ENGINEER'S DAILY REPORT

04-SF-80-13.2/13.9
Contract No. 04-0120F4
{SAS Superstructure}

REQUEST FOR INFORMATION (RFI)

Subject: Ground Cable to Tower Base	
References: 270R1	
Sub/Sup: BLI	**Sub RFI #:** 45
Response Required by: 23-February-2007	**Response affects critical path activity?** Yes

WALKWAY AND ACCESS PLATFORM TO "E" LINE GIRDER AT ELEV 53.85 m
SCALE 1:40

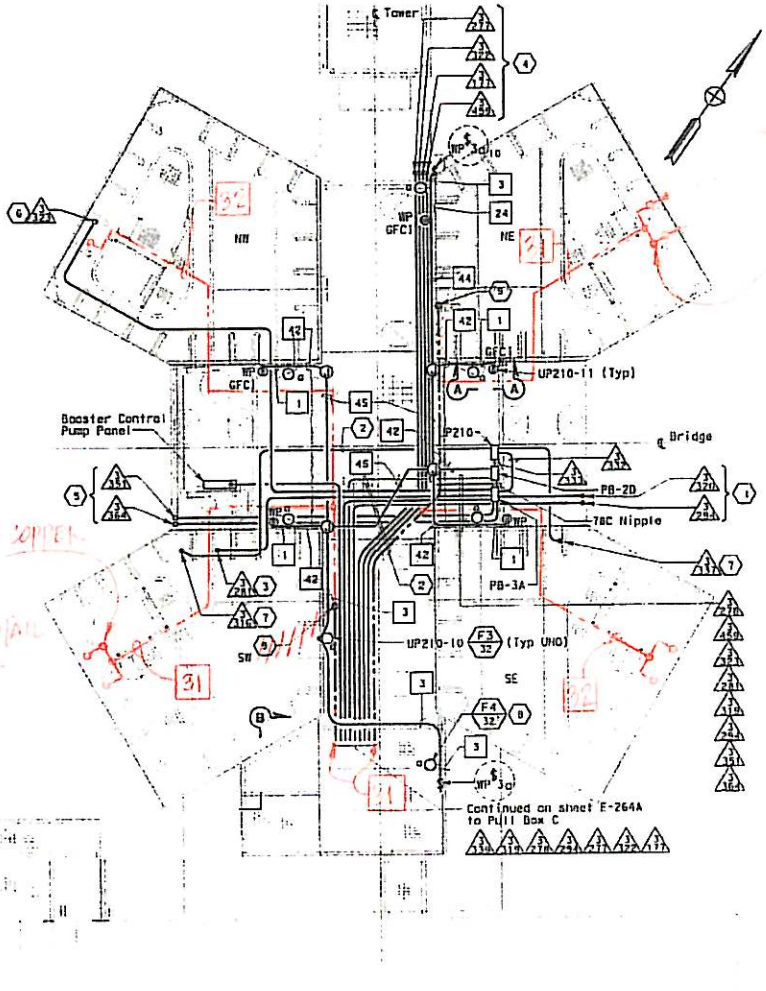
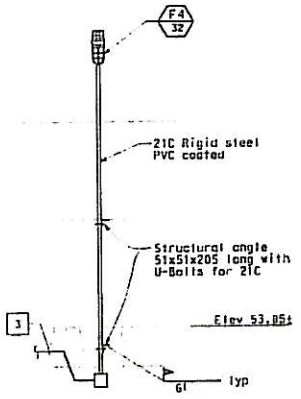
Penetrations have been provided through the girder (RFI 453, CWS6) for the 250 kcmil ground from the west girder to the NE and SW tower rebar. Revised sheet 270 provided with RFI 252 shows both grounds running vertically on the exterior of the D plate down to Elev 3 where it is connected to the footing rebar via a pigtail furnished by others.

1. Please confirm that it is acceptable to run the ground on the exterior of the tower.
2. Please provide the connection detail to the skin plate. Is it exothermically welded to the tower at intervals?
3. Please confirm the location of the pigtail furnished by others. Is it exterior of the tower leg in the vicinity of the D plate? If it is inside the tower leg, what is the route through the various plates?

1. Ground should not run on the exterior of the tower. Refer to item 3 for solution.

2. Ground should not be exothermically welded and connected to the skin of the tower. Refer to item 3 for solution.

3. The grounding pigtails at the T1 foundation shown on sheet 12 of 118 (Contract 04-0120E4) have not been installed as confirmed by CT and the E2 & T1 contractor. Based on sheet 12 of 118 document, the grounding pigtails are to be provided and installed by E2 & T1 contractor outside the tower skirt. However, to facilitate the installation of tower grounding conductor, we have requested that these pigtails be placed and to stub up inside the tower SW and NE quadrants as specified on the attached redlines of sheet 12 of 118. These locations will allow the grounding conductors to be routed within the tower without penetrating the lower tower skirt plate and the exterior skin plate.
The two 250 Kcmil ground conductors shown at elevation 53.0 m will be routed within the tower as shown on redlines sheet 270 of 1204. One ground conductor will penetrate the tower skin plate A of the SW quadrant and will be routed through the SW quadrant diaphragm utility openings down to the T1 foundation area at elevation 3.0 m. The other ground conductor will penetrate the tower skin plate A of the NE quadrant and will be routed through the NE quadrant diaphragm utility openings down to the T1 foundation area at elevation 3.0 m.

WALKWAY AND ACCESS PLATFORM TO "E" LINE GIRDER AT ELEV 53.85 m

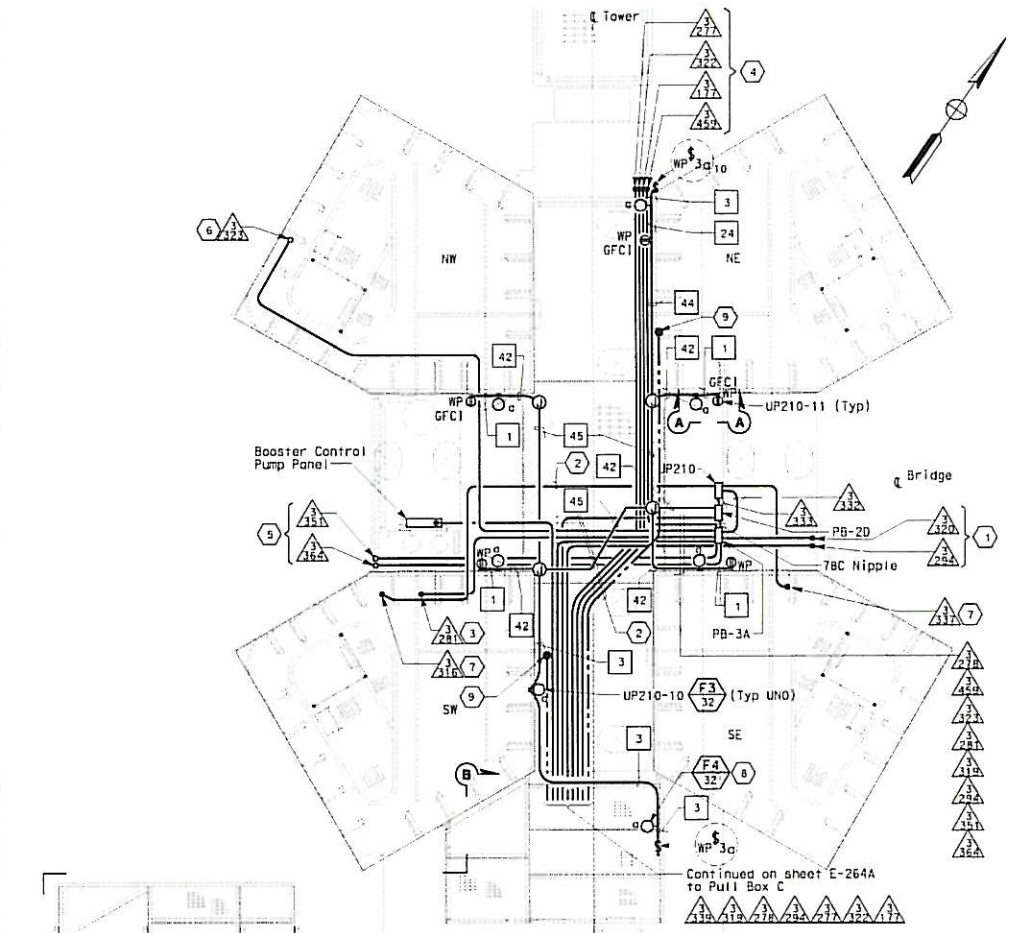
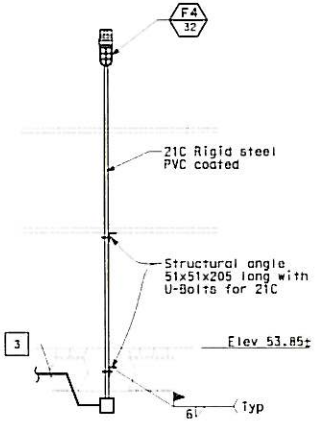
During the meeting this afternoon while going through the 3D model for the electrical conduits at elevation 53.85 I discovered a problem with the routing of the Ground Cables from the tower base.
The plate penetrations on the A-Plate on the NE, SW and NW towers have a 27mm hole for the cable to be routed through.
I don't think we want a bare copper cable coming out of the tower structure and go to the box on the southwest section of the elevation 53.85 grating area.
Exposed copper in a marine environment is not a good idea especially the main grounding cable at the tower structure.

In RFI # 564 the issue of having the bare copper cable on the exterior of the tower was addressed.
The ground cable was getting installed inside the structure at elevation 3.0.
The cables at elevation 53.85 has the cable still being exposed out side the structure.

I would recommend having all the ground cables installed in conduit outside the tower structure.
The doubler plates only have a 27mm opening for the cables.
I would enlarge the opening and install a conduit system for the ground cable outside the structure.
